Bid Bulletin #02

PROJECT: Educare of Winnebago
Bid Package #04
Winnebago, NE

ADDENDUM G

Educare Winnebago
Winnebago, Nebraska
RDG Project No. 2010.175.00, File 35.1

SDSP-01

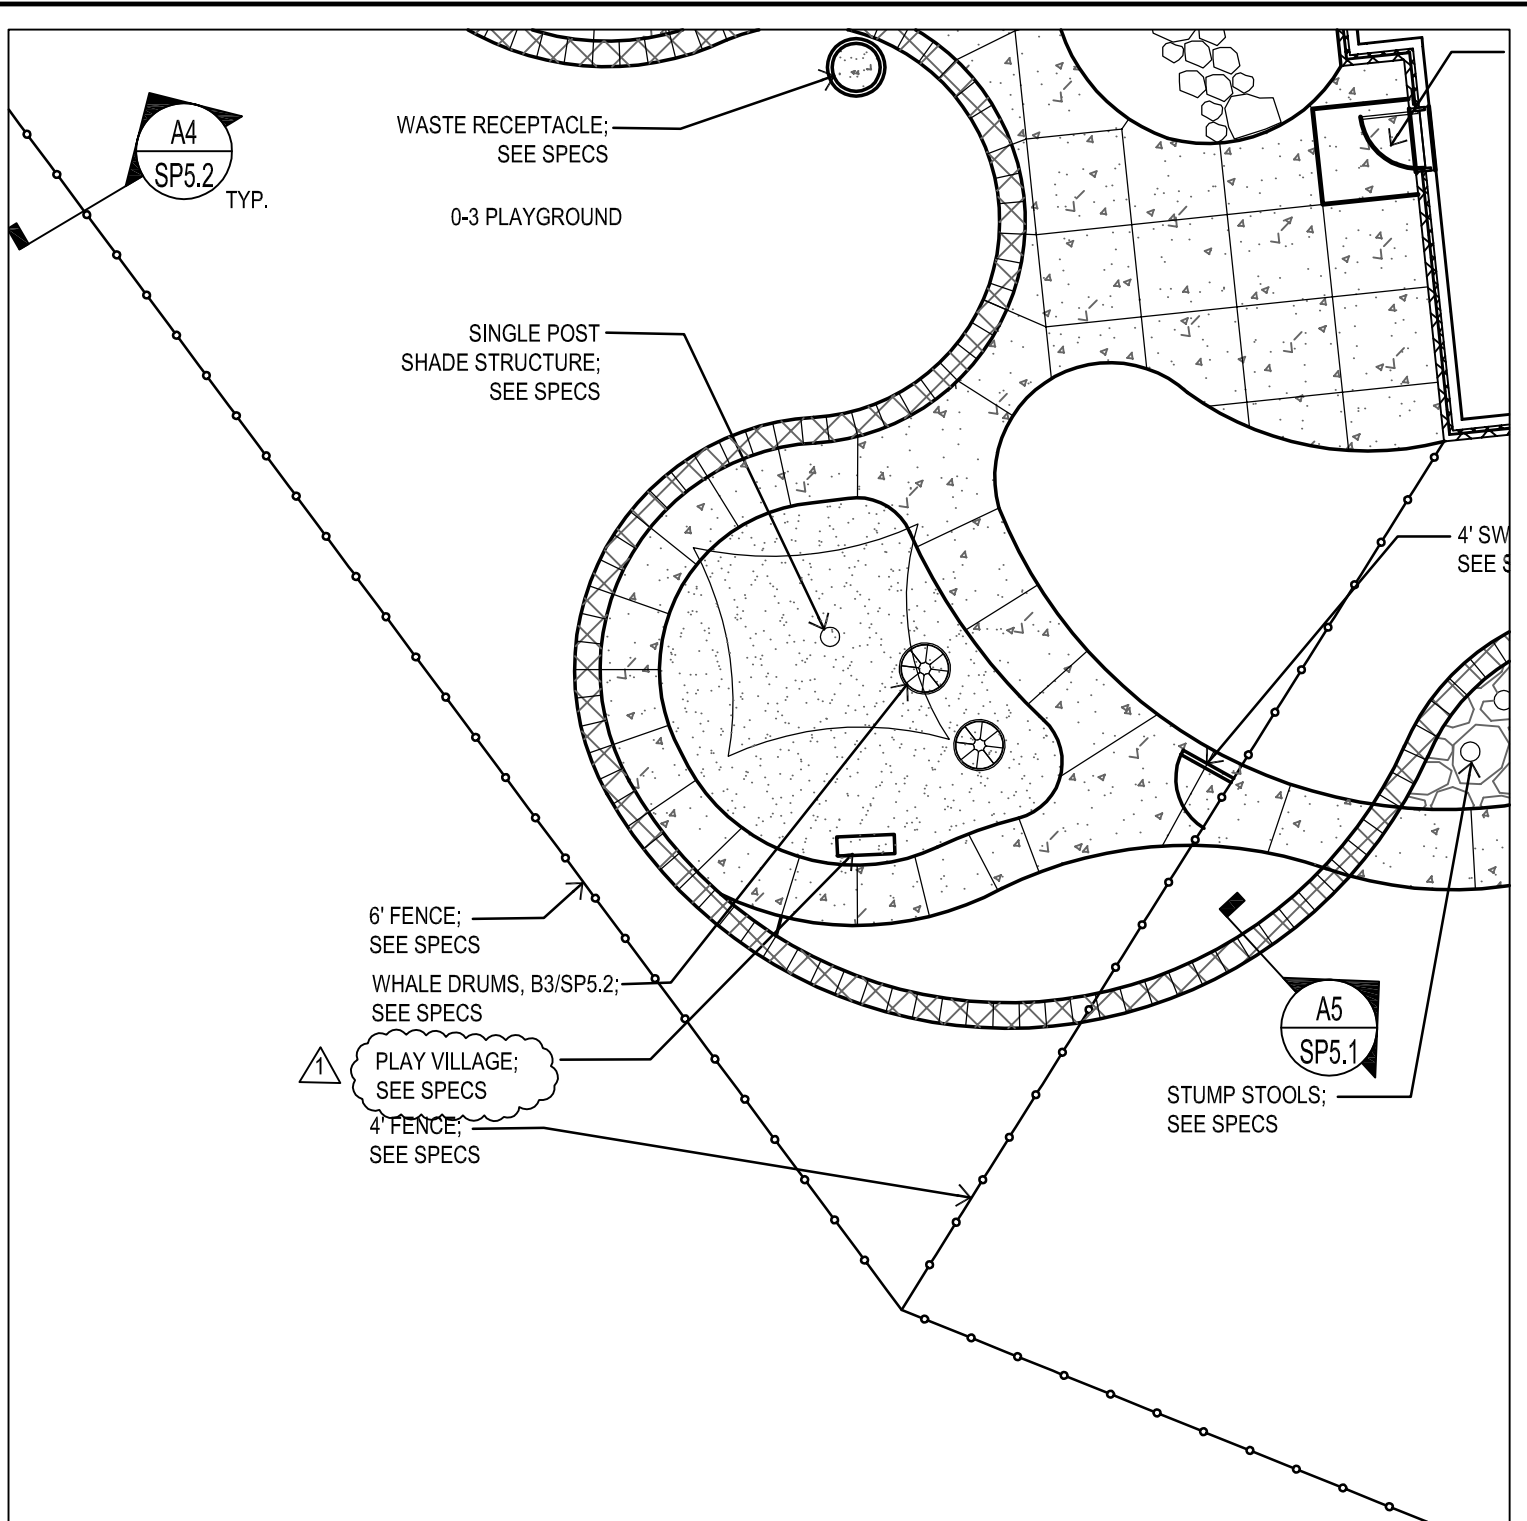
- GLD-1 Sheet SP3.4:
- A. Revise call out to read ***"PLAY VILLAGE"*** instead of "GAS STATION." See attached Supplemental Drawing SDSP-01.
 - B. Revise call outs, remove whale drum, add Amadinda, and revise storage shed layout. See attached Supplemental Drawing SDSP-02.

SDSP-03

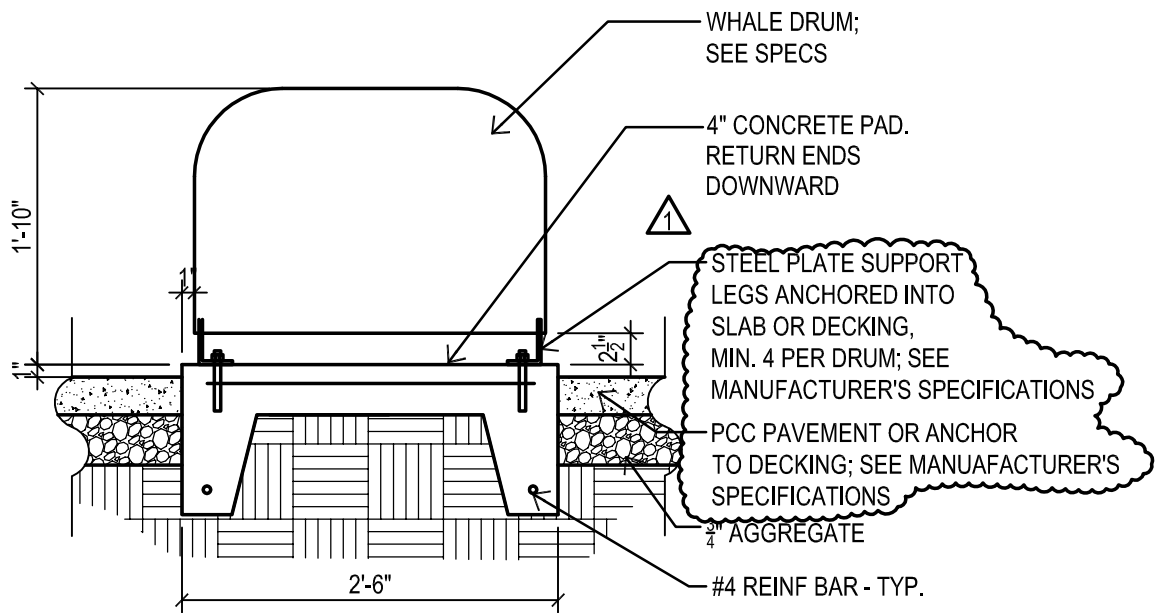
- GLD-2 Sheet SP3.1: Update Legend as shown in attached Supplemental Drawing SDSP-03.
- GLD-3 Sheet 3.2: Update Legend as shown in attached Supplemental Drawing SDSP-03.

- GLD-4 Sheet 3.3: Update Legend as shown in attached Supplemental Drawing SDSP-03.
- GLD-5 Sheet 3.4: Update Legend as shown in attached Supplemental Drawing SDSP-03.

- GLD-6 Sheet 3.5: Update Legend as shown in attached Supplemental Drawing SDSP-03.
- GLD-7 Sheet SP5.2. Remove decomposed granite, add PCC sidewalk, and revise note as shown in attached Supplemental Drawing SDSP-04.

2010.175
 45.2
 SDSP-05

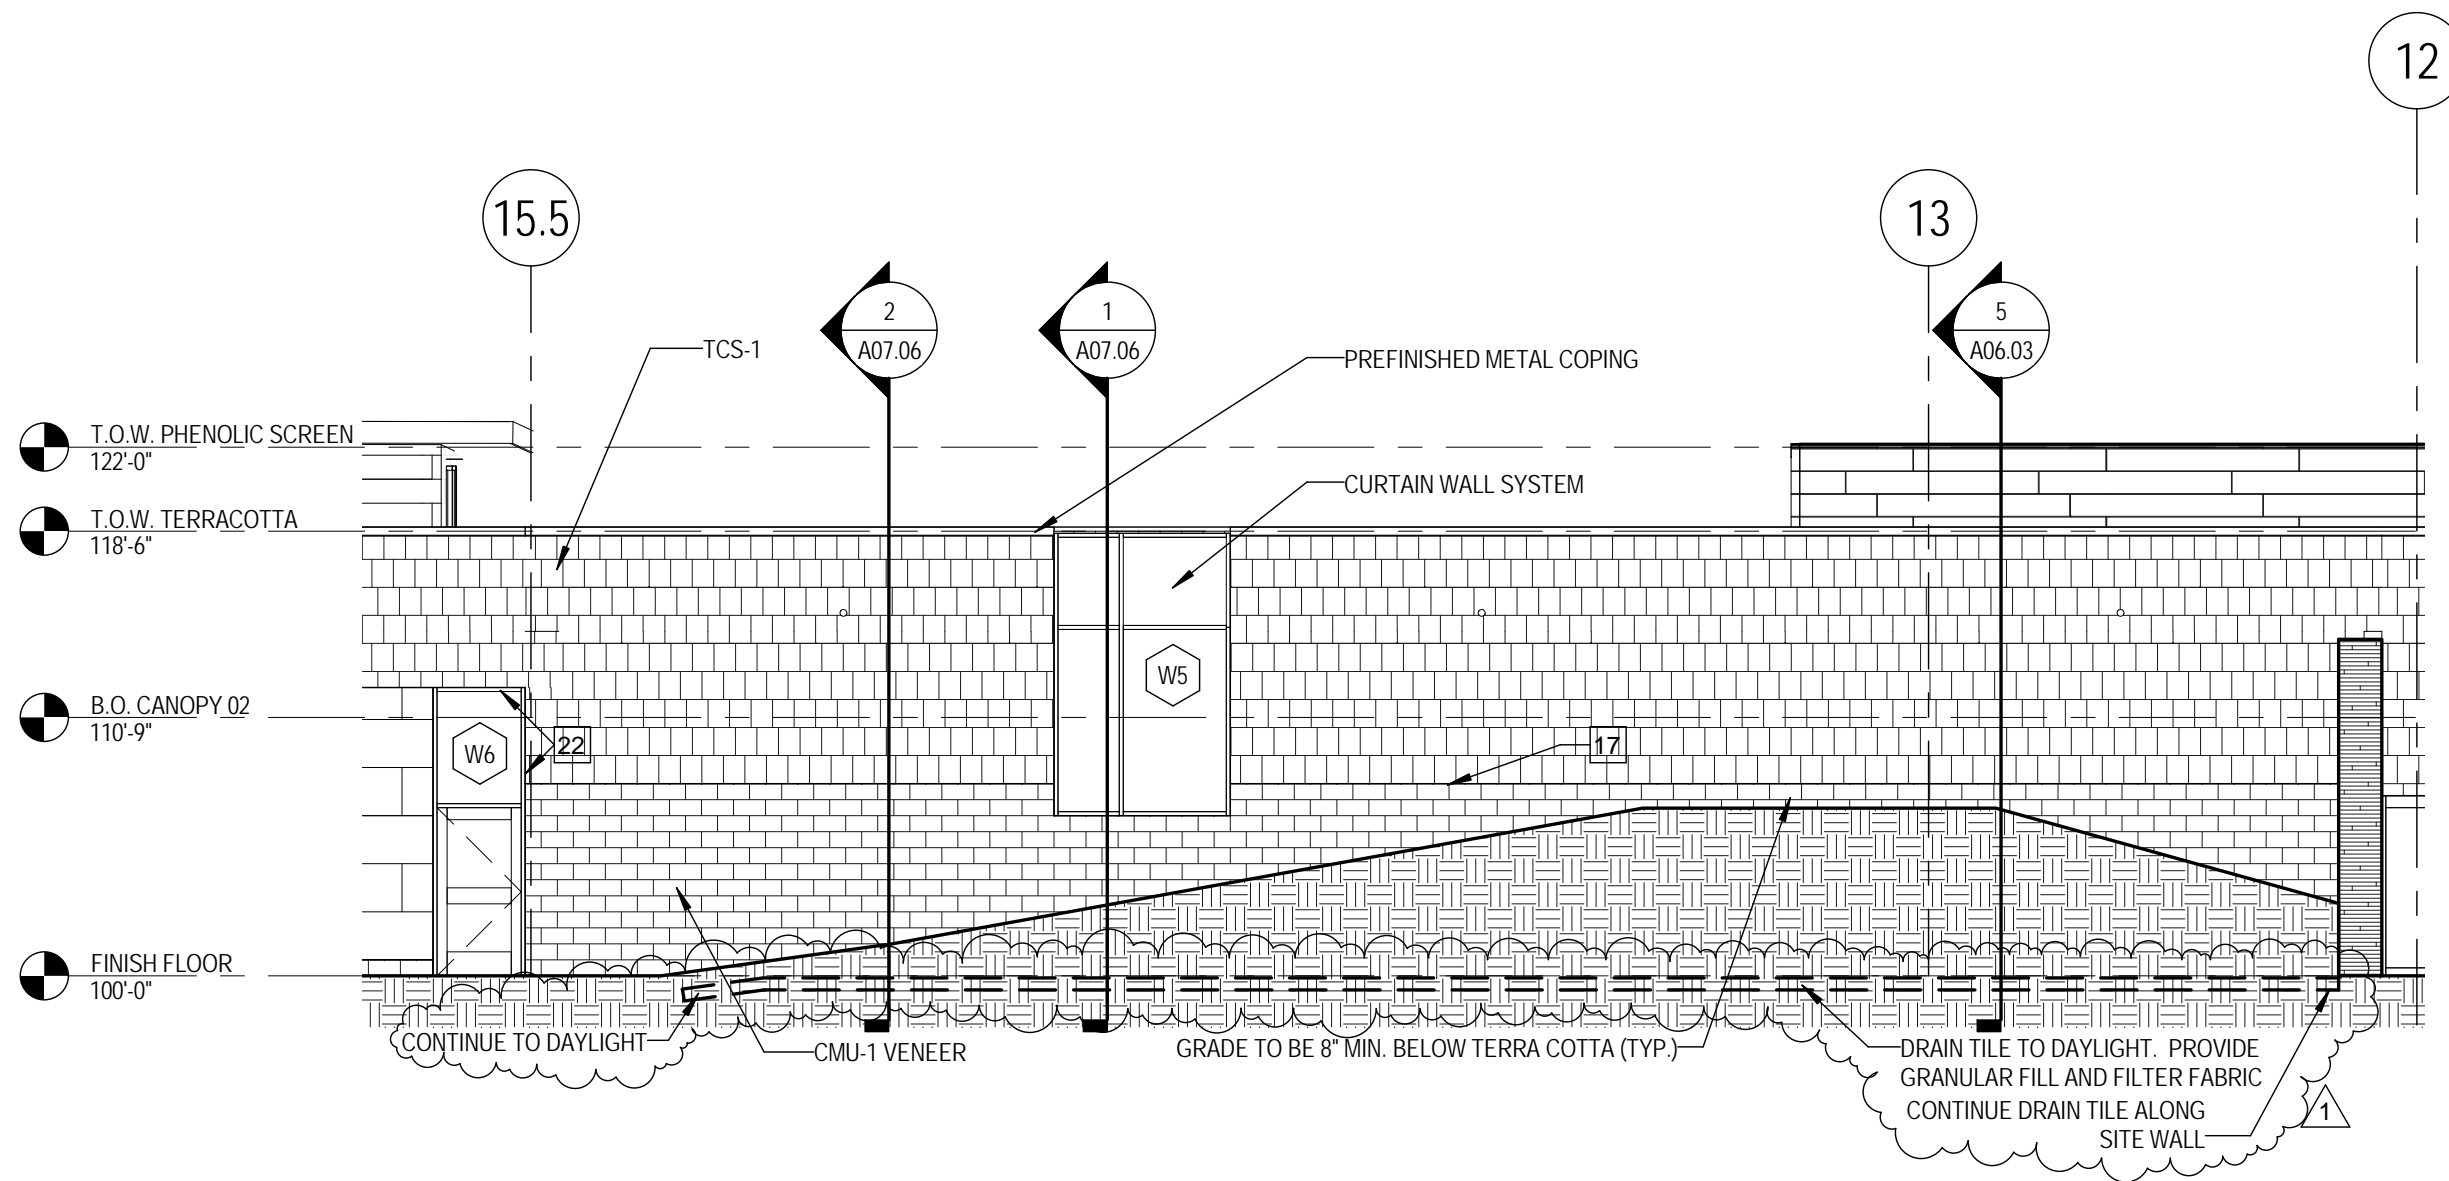
- GLD-8 Sheet SP5.3. Remove drain tile from southwest Bioretention Cell. See attached Supplemental Drawing SDSP-05.

2010.175.01
 45.2
 SDA-007

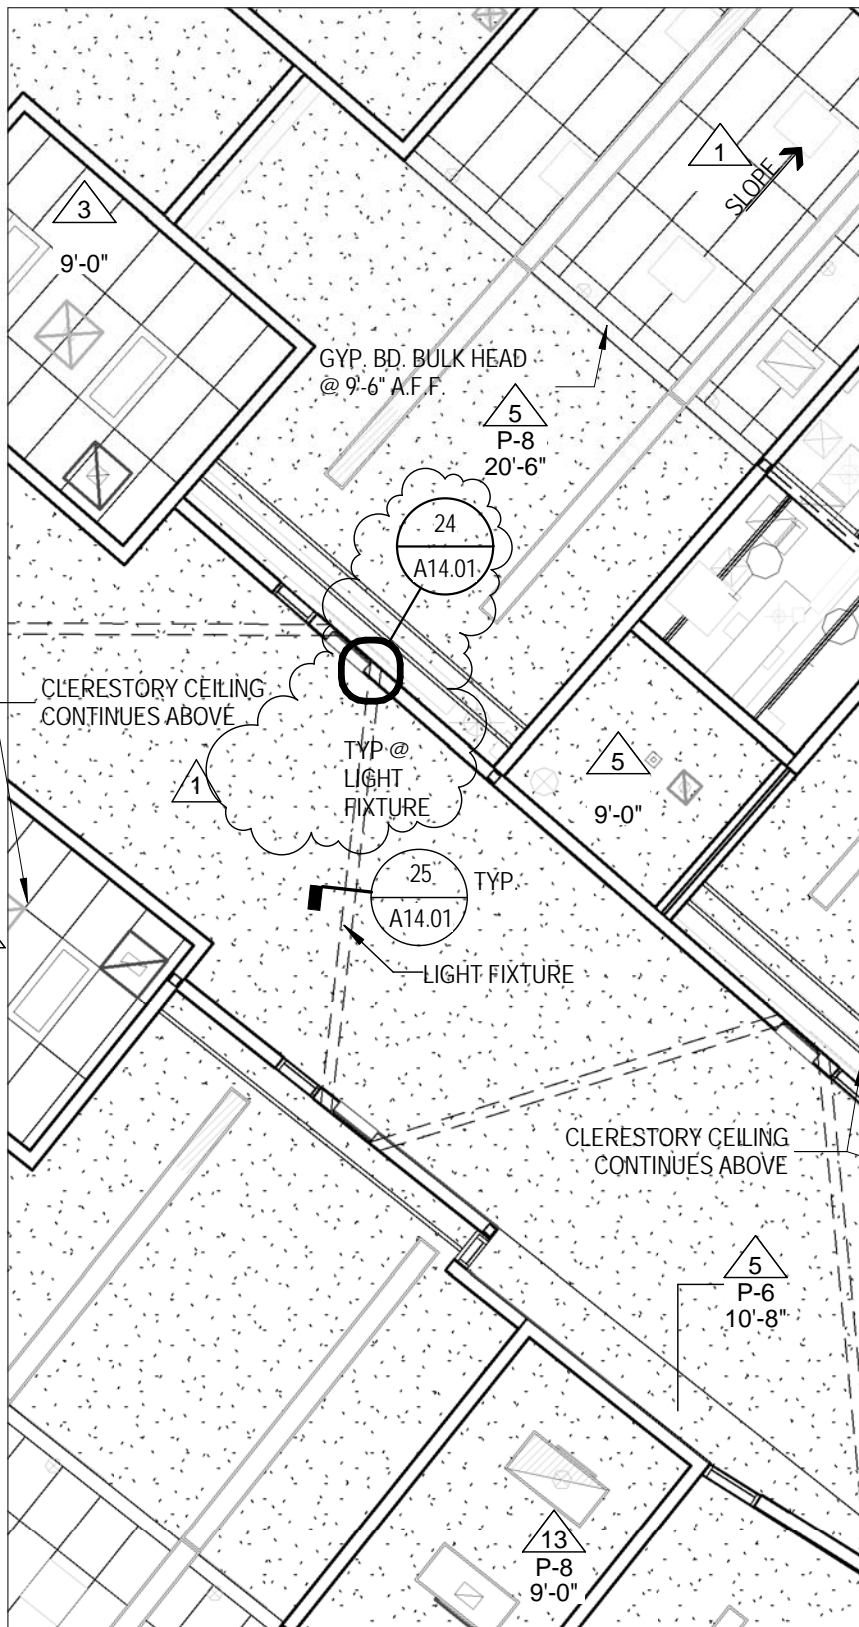
- GGD-5 Sheet A5.01, Exterior Elevations: See attached Supplemental Drawing SDA-007 with the following revisions:
- A. Add location of drain tile.
 - B. Add Notes 1, 2, and 3 as follows:

- 1. CONTINUE TO DAYLIGHT.***
 - 2. DRAIN TILE TO DAYLIGHT. PROVIDE GRANULAR FILL AND FILTER FABRIC.***
 - 3. CONTINUE DRAIN TILE ALONG SITE WALL.***
